Comment Set A15  
U.S. Department of Agriculture, San Bernardino National Forest

**RE: Draft EIR/EIS Southern California Edison Company's Application for the Devers-Palo Verde No. 2 Transmission Line Project: SCH #2005110104/ EPA OEPC Control No. DES-06-20**

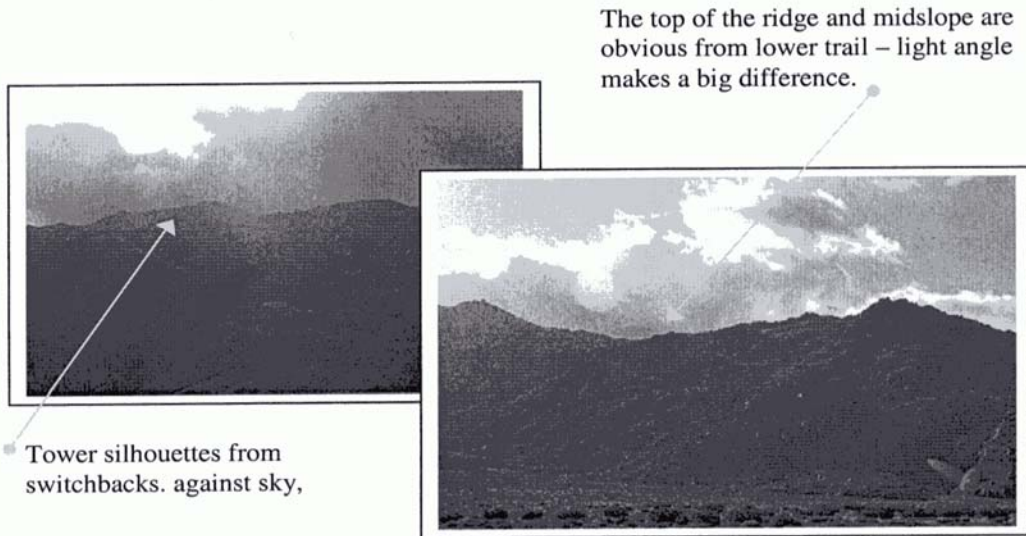
Currently, the existing Devers-Valley 500 kV line is a powerline that crosses approximately 1.8 miles of National Forest System land within an area designated as the San Jacinto Wilderness. Outside the wilderness boundary are apparently private lands but they are within the Santa Rosa & San Jacinto Mountains National Monument Lands. The comments on the Visual Quality are concerned with National Forest System Lands but the comments on the Pacific Crest Trail are both within the National Forest as well as the private lands outside the National Forest System boundary.

The current transmission line is seen from 4 important viewpoints of which the Forest Service Visual Management System Defines as Concern Level 1 and are listed in the order of importance of concern.

First, the silhouette of the towers is seen from the Pacific Crest Trail from within the National Forest in Sections 28 and 29. The towers are seen along side of the hill immediately east of Snow Creek and prominently as they cross the ridge. Since the movement of recreation hikers is slow, in both directions and the trail switches back and forth across a neighboring ridge, the views are often, obvious and direct.

A15-2 The high visibility of the Devers-Valley No. 2 Alternative route from the viewpoints described in the comment is acknowledged, and is consistent with the conclusions of the visual analysis presented in Section D.3.9.1. The comment describes views of the route from a different viewpoint than that considered in the EIR/EIS.

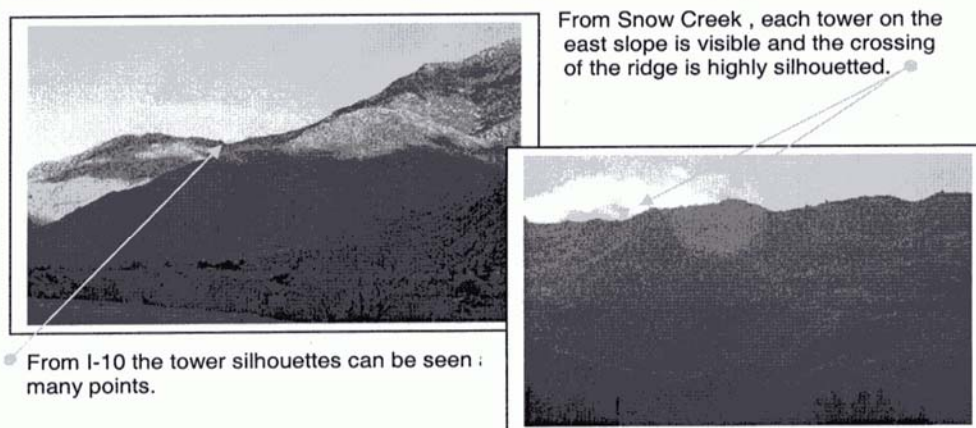
Second, is the view from the Pacific Crest Trail north out side the National Forest System lands out but south of the crossing point of I-10. The towers are obvious during certain light conditions on the east slope of the ridge immediately west of Snow Creek village. The line descends the slope and crosses the Trail and at least 5 towers are very obvious west of the trail.

Third, the silhouette of the tower line as it crosses the top of the ridge as seen from both directions of I-10 most of the time and on the east slope of the ridge west of Snow Creek at certain light conditions. The lattice tower structures are seen from both directions of travel by driver and passengers who view the grandeur of the San Jacinto Mountains. This is an obvious view in the driver's cone of vision at some limited points but is not an obvious direct view at all times. The primary seen periods would be by passengers viewing the San Jacinto Mountain – a long term view potentially viewed by many people but not a large prominent view.
